ADDENDUM No. 4

Gerry B. Green Plaza Alterations

Union County Improvement Authority

DATE: August 1st, 2025
RSC Project Number: 158.25.001

1 ELECTRICAL 1ST FLOOR POWER PLAN
SCALE: 1/8" = 1'-0"

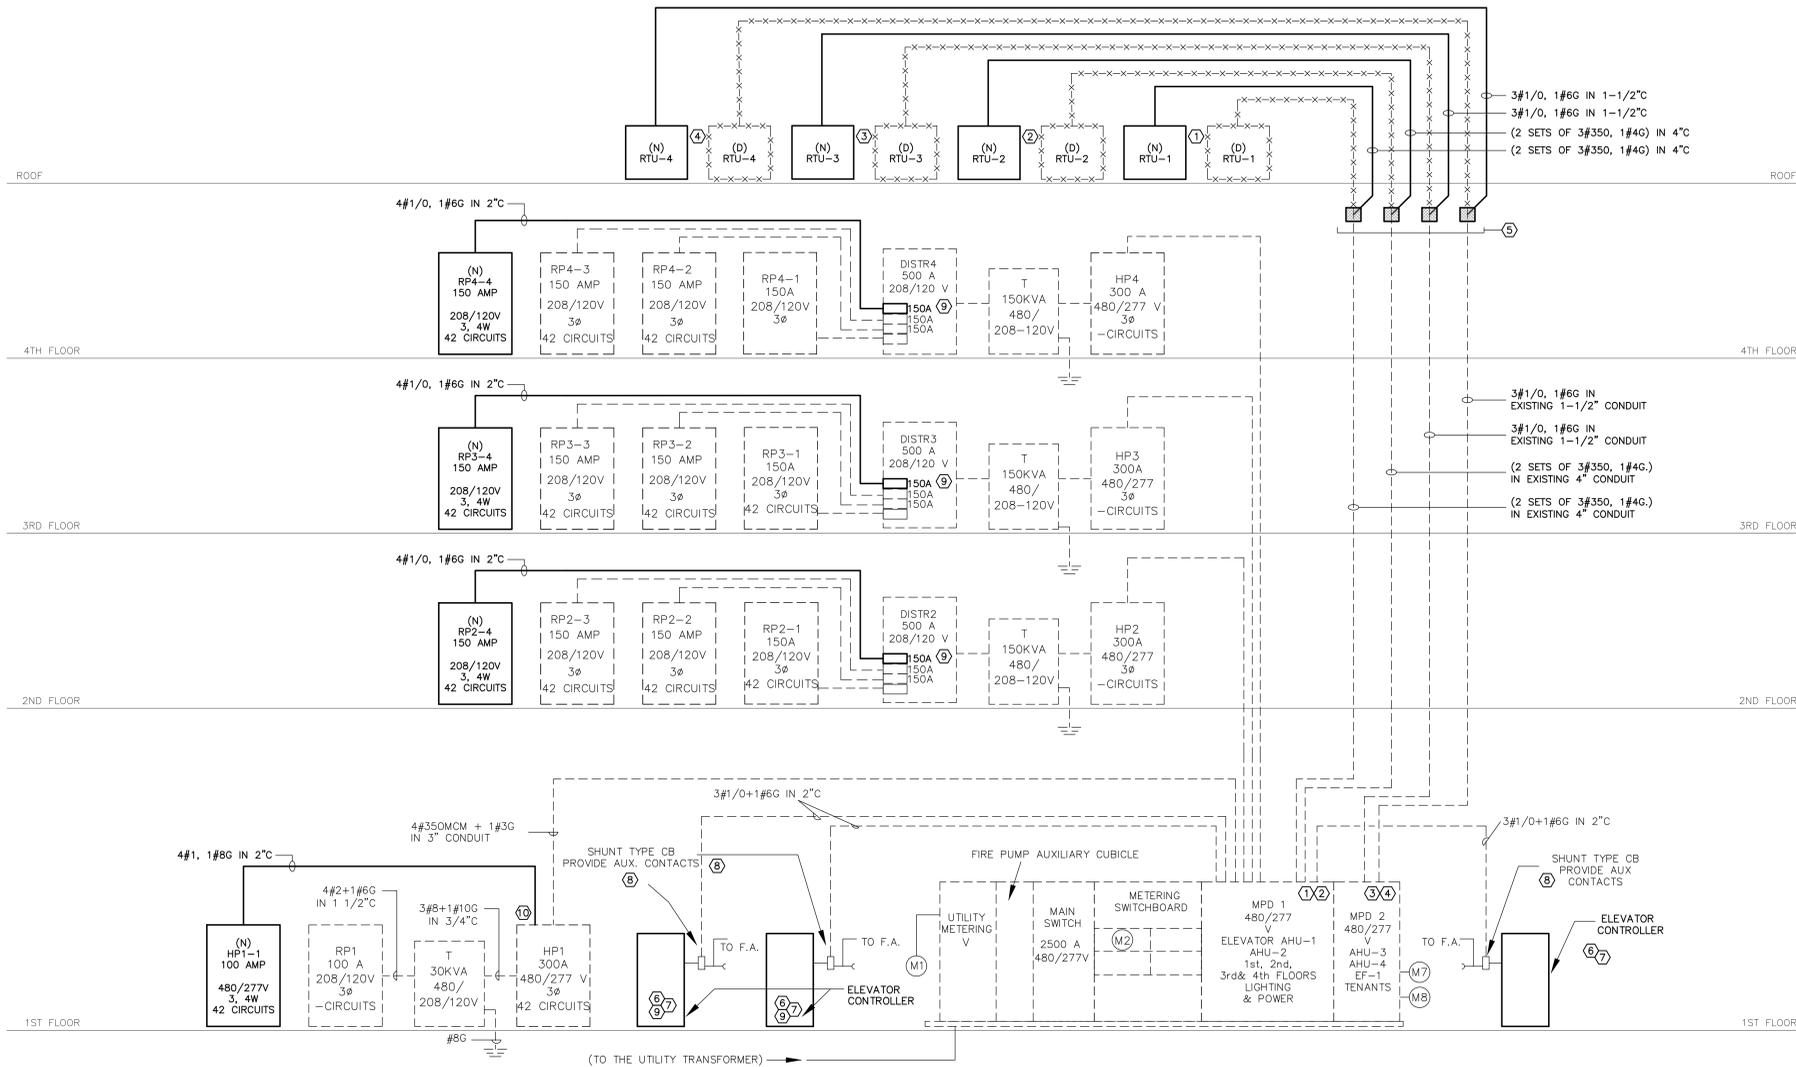
1. *Dwg E-101, Keynote 6 – Are we to assume that the Circuit is 277V for bidding purposes? How are we to know if it isn't?*

2. *Dwg E-101, HP-1-1 – Are we still transferring # 1,3 & 5 for the Elevators if Alternate # 1 is not accepted?*

For bid purpose, assume a new circuit must be ran from panel noted. Verify circuit source and voltage in field. If circuit is found to be 277v provide credit.

Refer to revised drawings provided as part of this addendum.

- EXISTING HVAC EQUIPMENT TO BE REMOVED AND REPLACED BY MECHANICAL CONTRACTOR. VERIFY VOLTAGE AND SOURCE OF EXISTING CIRCUIT SERVING UNIT. IF THE CIRCUIT IS 277V, THE CIRCUIT MAY BE RE-UTILIZED. IN THE EVENT THE CIRCUIT IS NOT 277V, ELECTRICAL CONTRACTOR TO DISCONNECT AND REMOVE CONDUIT AND WIRING ENTIRELY BACK TO SOURCE. PROVIDE NEW ELECTRICAL CIRCUIT FROM NEW SOURCE AS NOTED.
